STATE OF MAINE
DEPARTMENT OF TRANSPORTATION
16 STATE HOUSE STATION
AUGUSTA, MAINE 04333-0016

December 20, 2024
Subject: Intersection Safety Improvements
State WIN: 026284.00
Location: Chelsea
Amendment No. 2

DETAIL A - STRUCTURAL CONCRETE MEDIAN

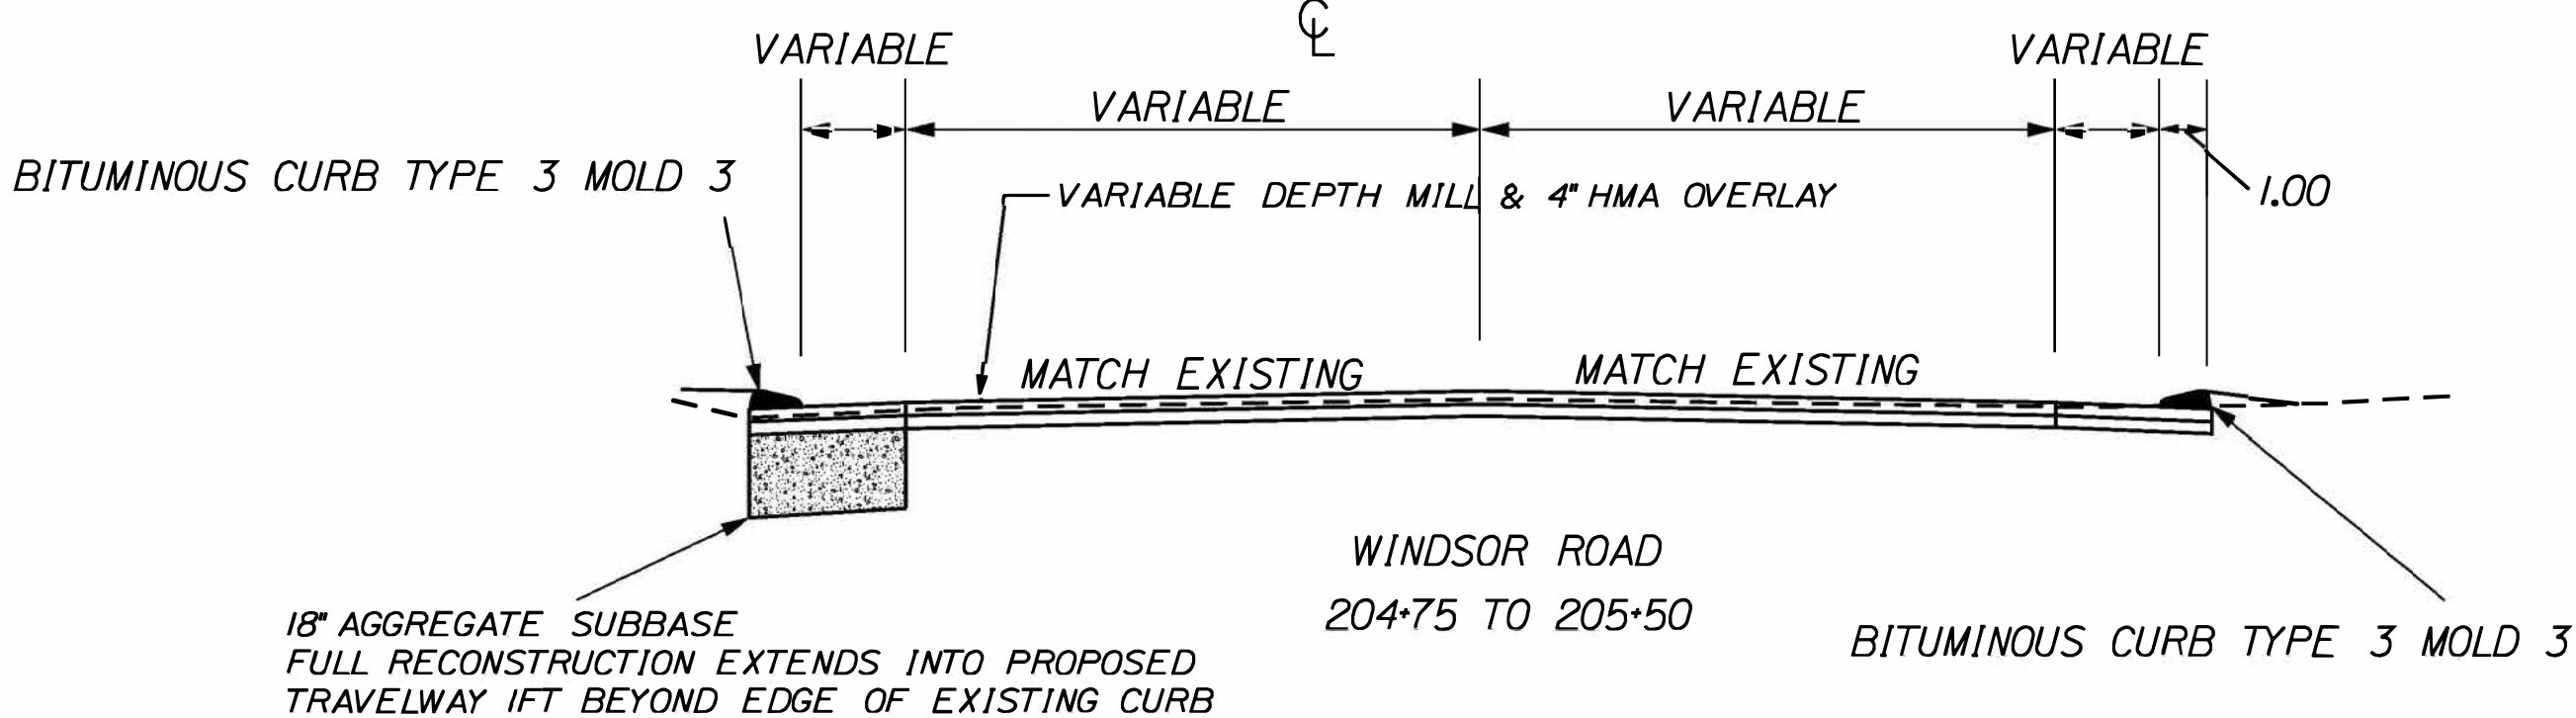
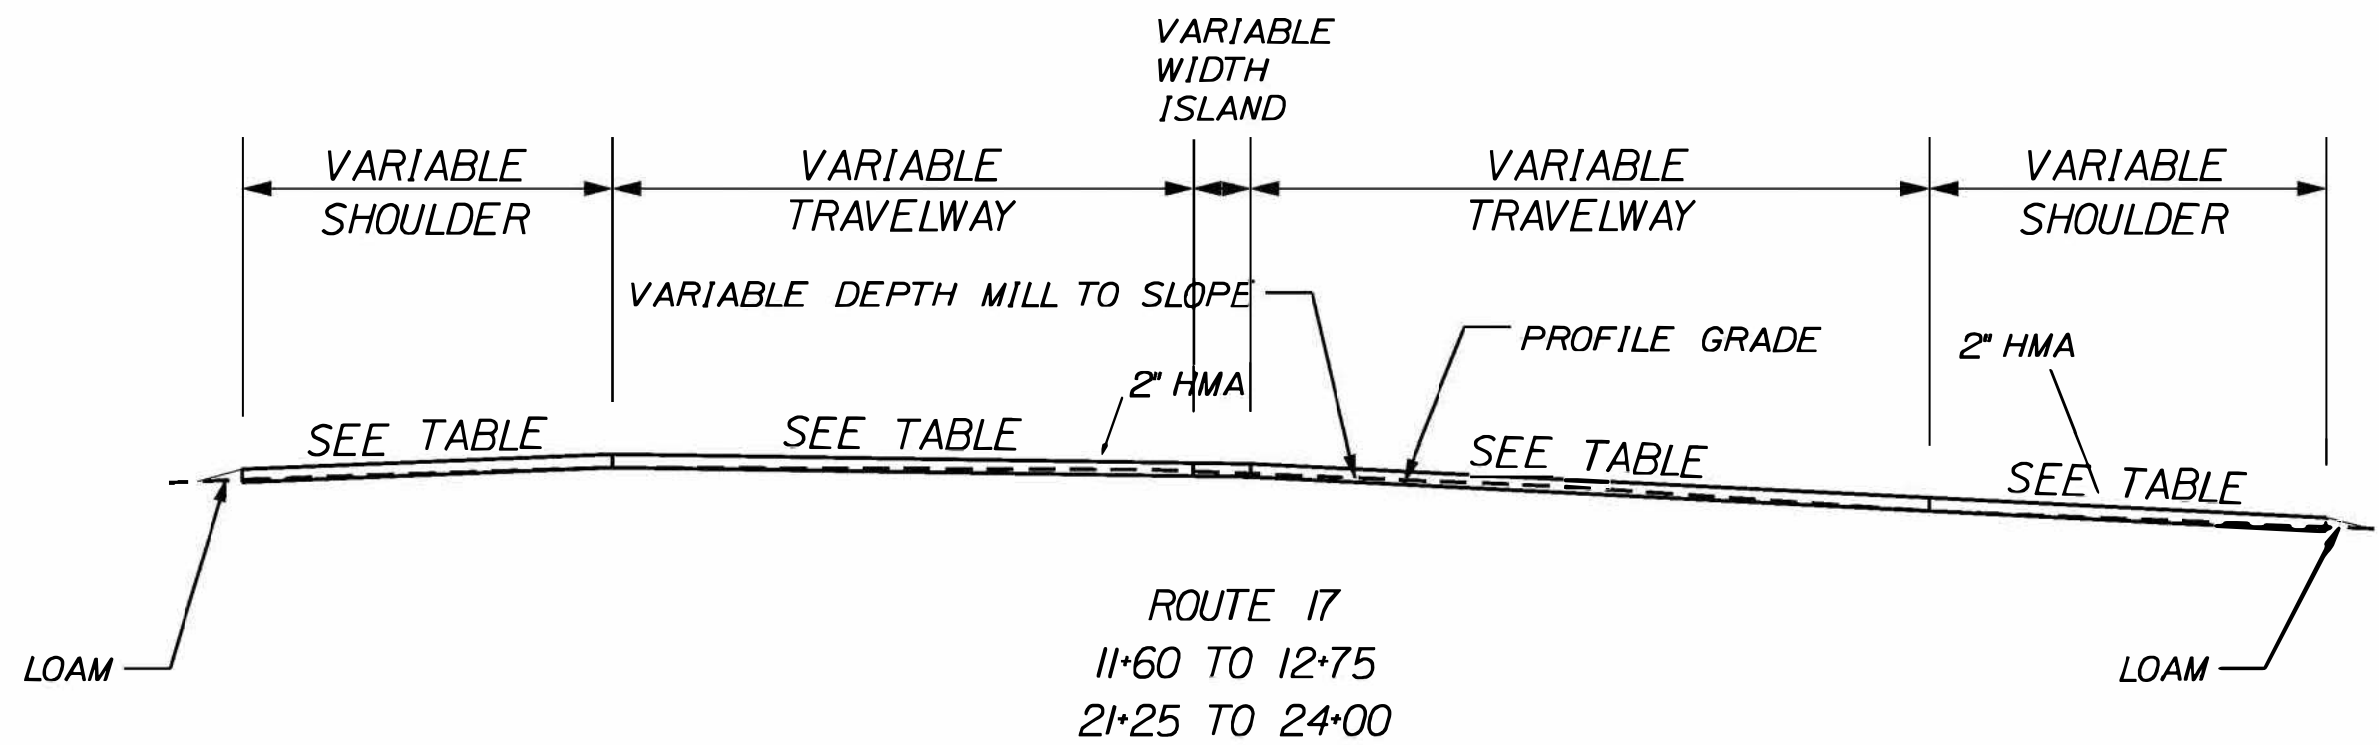
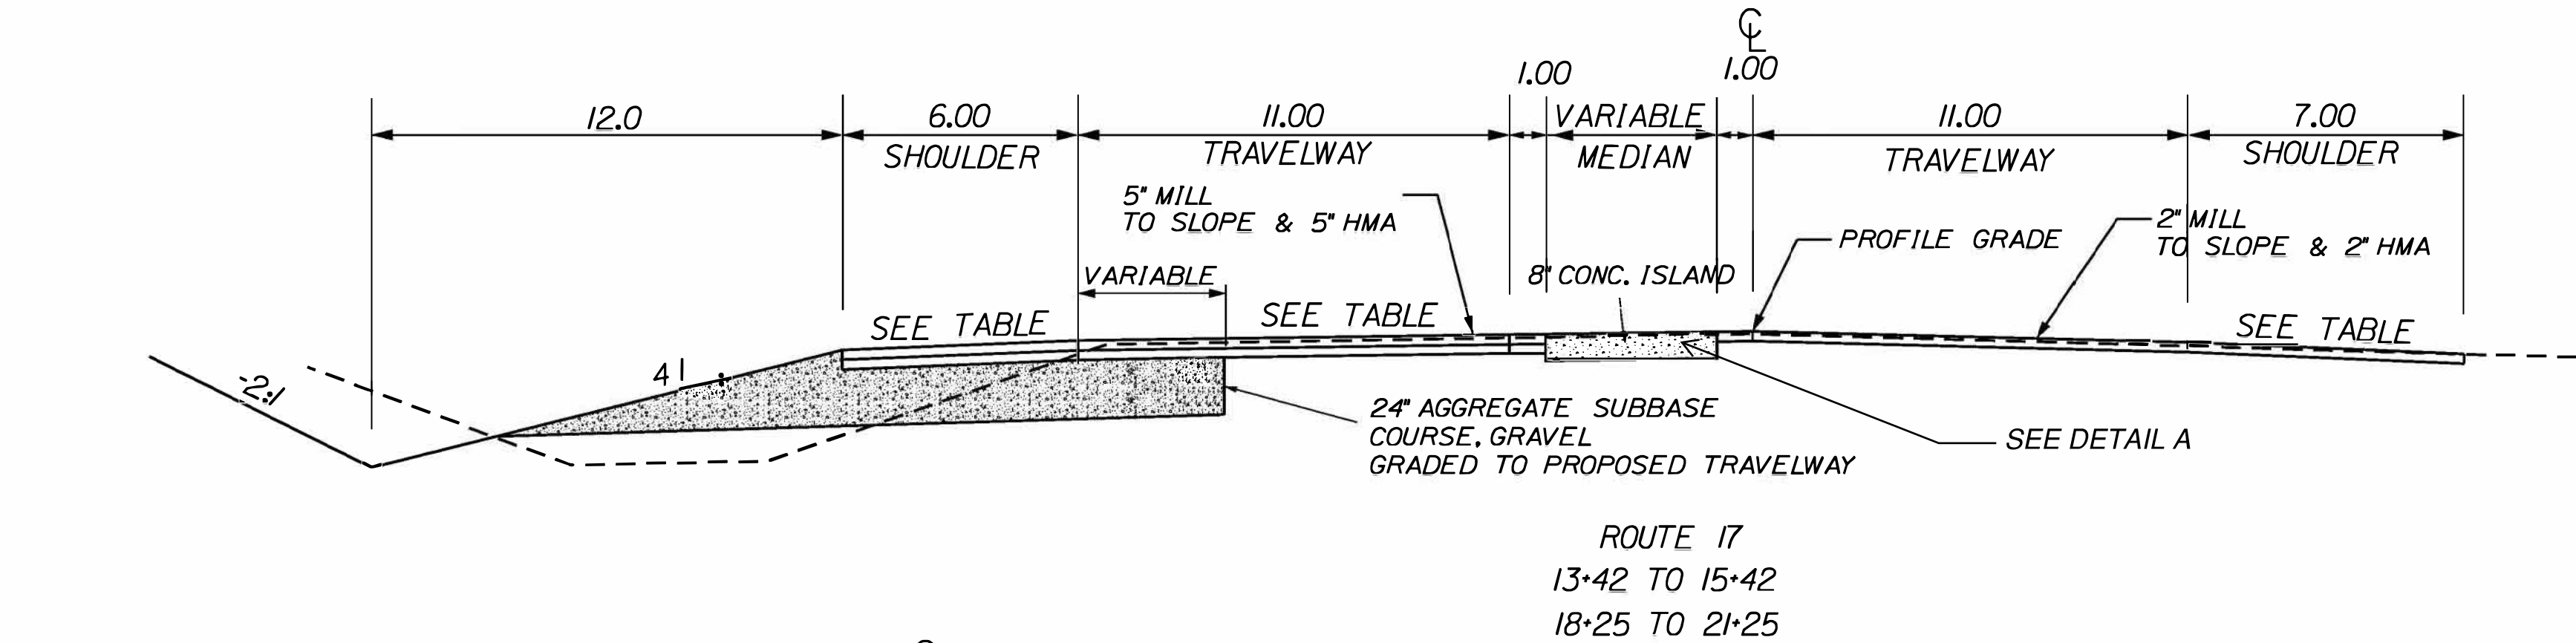
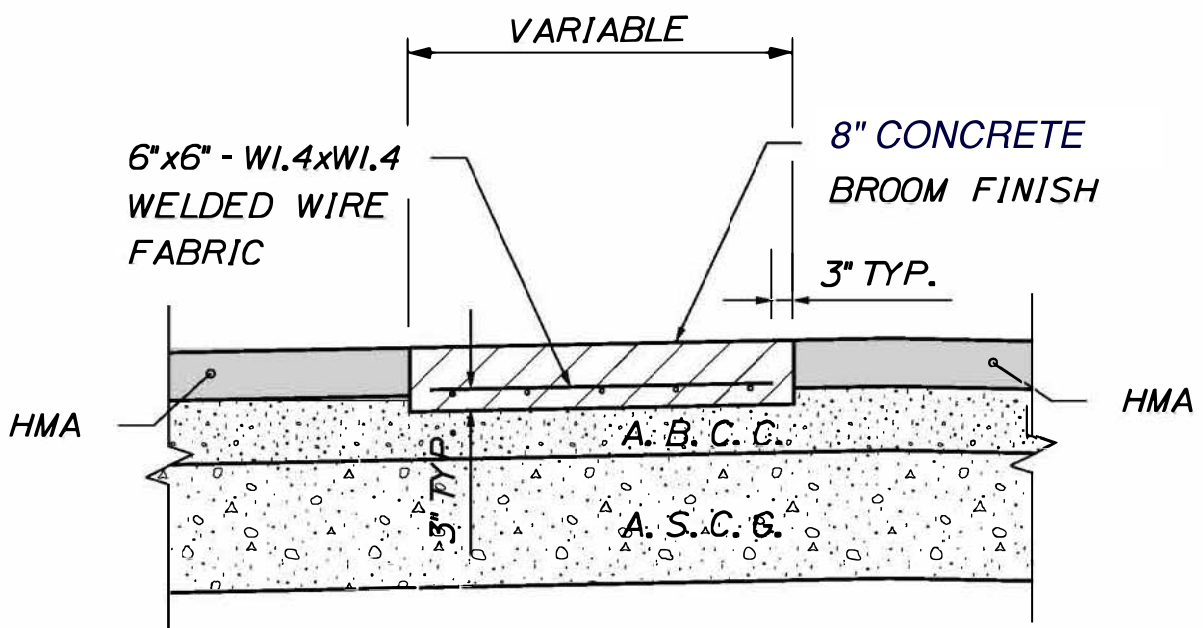
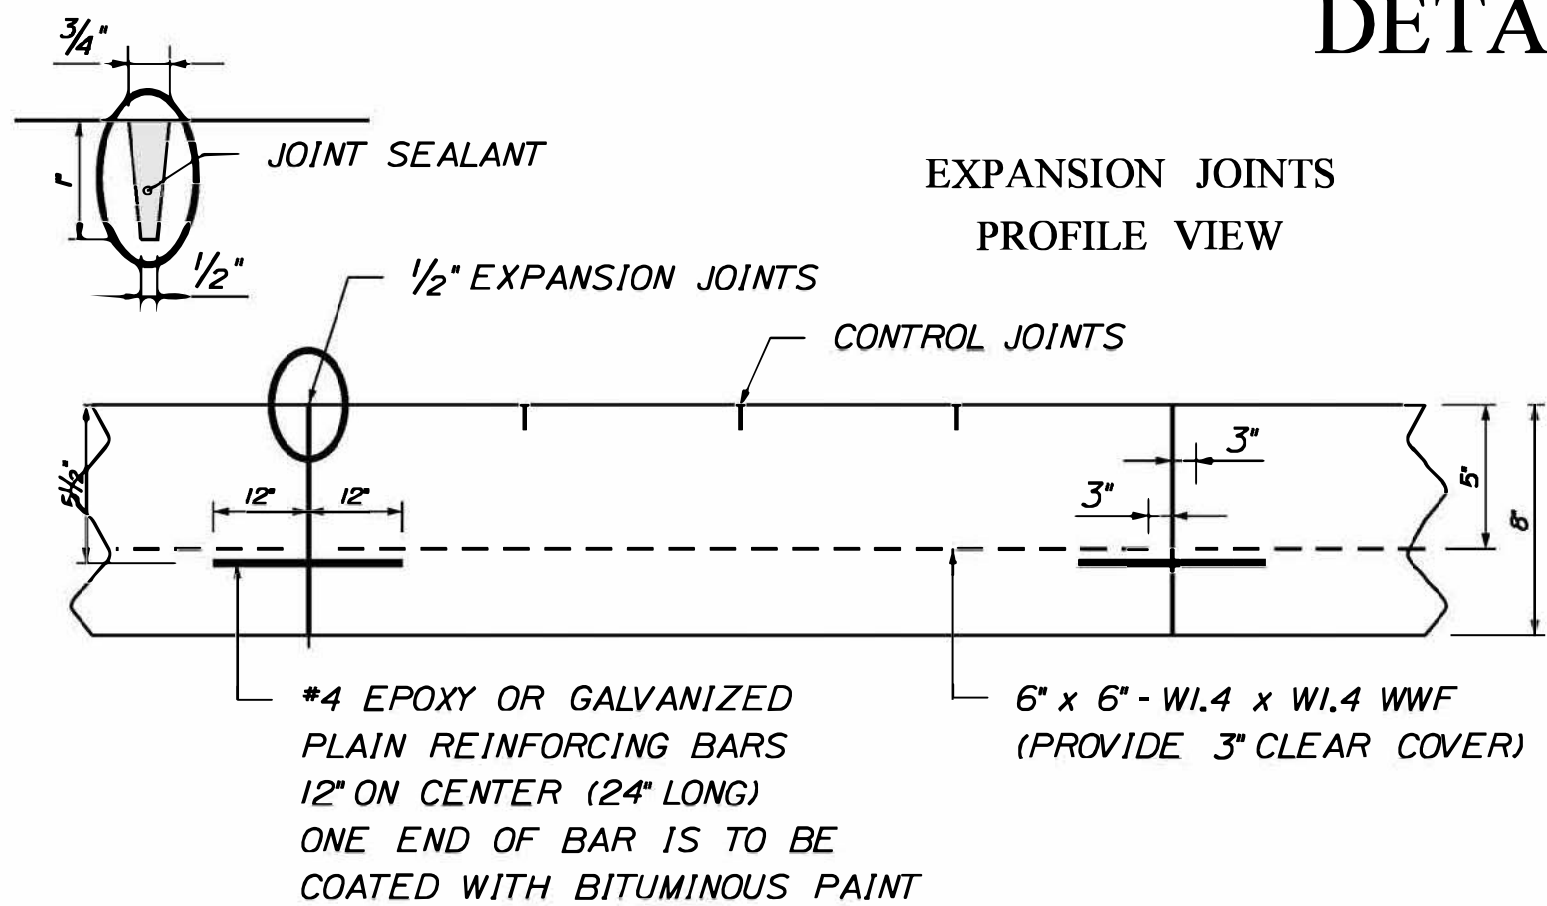
Question: Detail A on Sheet 02 says 8" colored concrete broom finish. Does this project require color?

Question: Is there a specified length between construction joints we need to have?

Question: Detail A on Sheet 2 of the plans references "8" Colored Concrete Broom Finish". There is no other reference that the Median Concrete is colored. Please confirm whether this concrete is colored and if yes, provide a specification for the coloring. With both these next few weeks being short weeks with holidays, please respond as soon as you can.

Response: The concrete is not colored. See attached revised Plan Sheet #2.

Response: Construction joints are not required. See revised Plan Sheet #2 and Special Provision Section 502 Structural Concrete (Roadway Median) Placement of Concrete in the bid book.

Response: The concrete is not colored. See attached revised Plan Sheet #2.
